PROJECT NAME: YPSG PROJECT

PROJECT NUMBER: 2024080051

APPLICATION: MINOR SITE PLAN #32396

C001

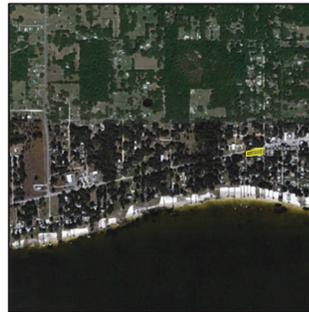
- 4 DEPARTMENT: ZONE - ZONING DEPARTMENT  
REVIEW ITEM: 4.4.4 - Sign (provisions for advertising signage), if it is a multi occupancy complex like shopping centers they must submit a master sign plan.  
STATUS OF REVIEW: INFO  
REMARKS: First Review 2/11/25 - Will there be a new on-site sign to replace the existing Oklawaha Hardware sign? If yes, show location on the Layout Plan and ensure compliance with Sec 4.4.4 and other sections of Div 4.4. as applicable. Additionally. confirm whether the new on-site sign(s) will require additional permitting per LDC Div. 4.4. If no, provide a note on C001 Cover Sheet addressing this item.

- 17 DEPARTMENT: ZONE - ZONING DEPARTMENT  
REVIEW ITEM: 2.12.4.L(7) - List and describe land use including floor area of particular use (example: office, warehouse, storage or assembly) these descriptions are often found in the summary of parking requirements but should be clearly shown on plan  
STATUS OF REVIEW: NO  
REMARKS: First Review 2/11/25 - Per 2.12.4.L.(7), provide the existing property use above "Proposed Use: Data Center" on C001 Cover Sheet.

- 25 DEPARTMENT: 911 - 911 MANAGEMENT  
REVIEW ITEM: Additional 911 comments  
STATUS OF REVIEW: NO  
REMARKS: Sheet C001 – Section Township Range is incorrectly labeled as 18-13-26 – It should be 5-17-24. Please correct on future submittals.

- 28 DEPARTMENT: ENRAA - ACQ AGENT ENG ROW  
REVIEW ITEM: Minor Site Plan  
STATUS OF REVIEW: NO  
REMARKS: Update owner's certificate signature block on coversheet to include the name (BROWN, REGINA A) as shown in Sunbiz. Also, Section, Township and Range do not correspond with the parcel, please update. FB 2/3/25  
Sec. 2.18.1.I - Show connections to other phases.  
Sec.2.19.2.H – Legal Documents  
Legal documents such as Declaration of Covenants and Restrictions, By-Laws, Articles of Incorporation, ordinances, resolutions, etc.  
Sec. 6.3.1.B.1 – Required Right of Way Dedication (select as appropriate)  
For Public Streets. "[All streets and rights-of-way shown on this plat or name specifically if less than all] are hereby dedicated for the use and benefit of the public."

C003

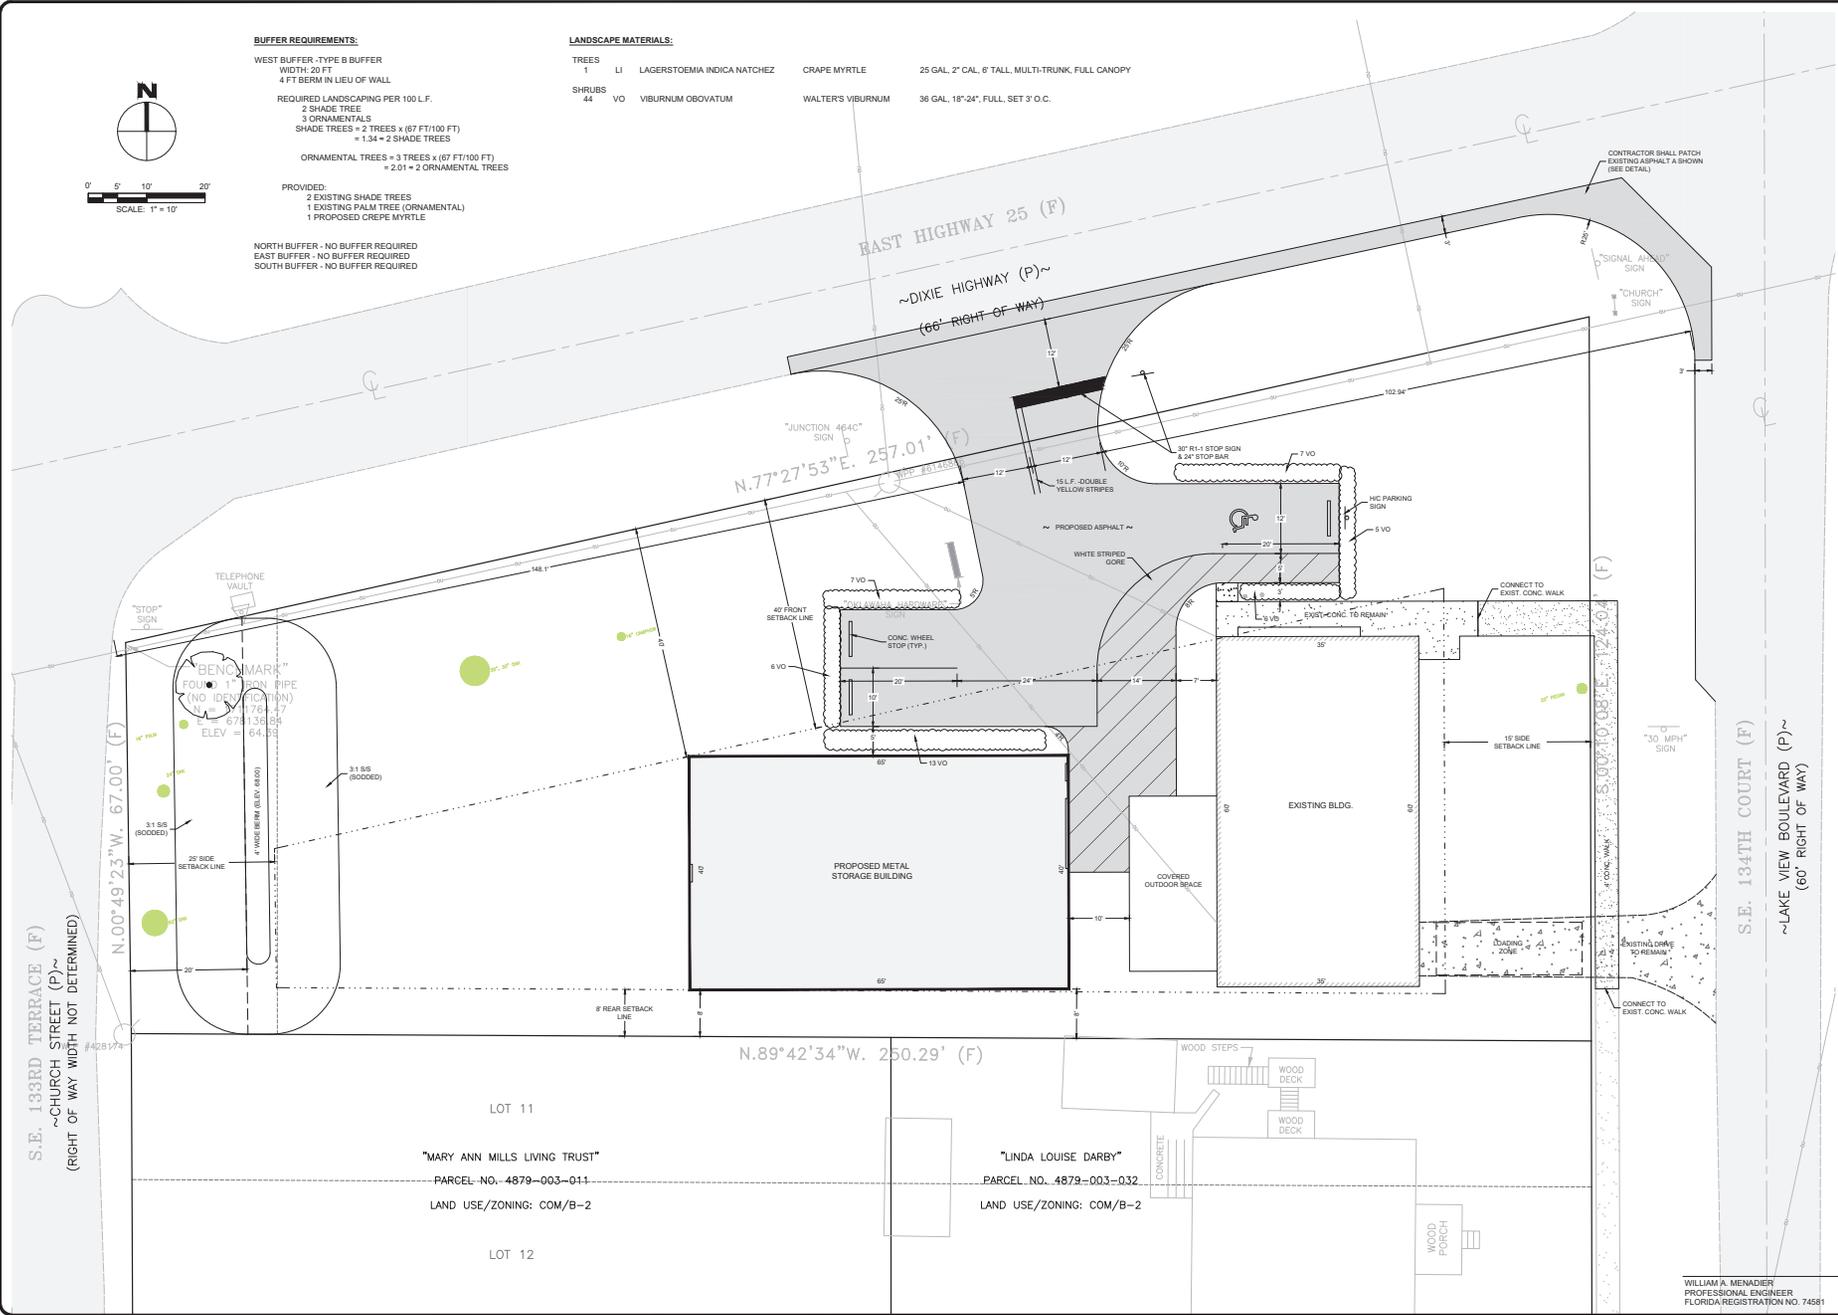
- 5 DEPARTMENT: ZONE - ZONING DEPARTMENT  
REVIEW ITEM: 2.12.27 - Show location of outside storage areas  
STATUS OF REVIEW: INFO  
REMARKS: First Review 2/11/25 - Please be advised that no outside storage is permitted on this property per Resolution No. 24-R-262. On C001 Cover Sheet, provide a note indicating the intended use for the "Covered Outdoor Space" listed on C003.

- 15 DEPARTMENT: ZONE - ZONING DEPARTMENT  
REVIEW ITEM: 2.12.23/4.2 - Setbacks, dimensions for all improvements, and easements  
STATUS OF REVIEW: NO  
REMARKS: First Review 2/11/25 - 15' side setback from SE 134 CT is mislabeled. Should be 25'. Please correct.

- 16 DEPARTMENT: ZONE - ZONING DEPARTMENT  
REVIEW ITEM: 2.12.24 - Landscape requirements, (buffering) 6.8.6  
STATUS OF REVIEW: NO  
REMARKS: First Review 2/11/25 - List and show the buffers required by Resolution No. 24-R-262 pertaining to this project's approved Special Use Permit. List and show additional required buffers under LDC Sec. 6.8.6 and Sec. 4.2.18.G, as applicable.

- 20 DEPARTMENT: ZONE - ZONING DEPARTMENT  
REVIEW ITEM: 2.12.19 - Provide dimensions and location of all existing site improvements; dimensions and location for all proposed site improvements with all setbacks  
STATUS OF REVIEW: NO  
REMARKS: First Review 2/11/25 - On C003, provide the dimensions of all existing and proposed improvements including, but not limited to, covered outdoor space, concrete walkway, existing driveway, loading zone, etc.
